HUSQVARNA TECHNICAL BULLETIN HTB2507 – USA

FUEL TANK CAP SEAL REPLACEMENT

AFFECTED MODELS:

2024 SVARTPILEN 401

Fig. 1: Collar metal ring

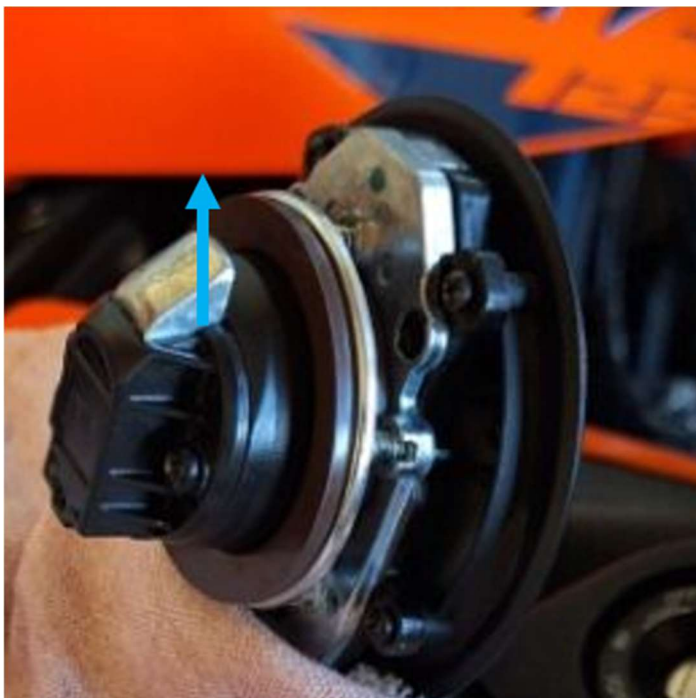
Attention: Ensure that the sealing lip of the new seal is seated correctly and that the metal ring is aligned correctly - the collar of the metal ring must point away from the seal, see Fig. 1.
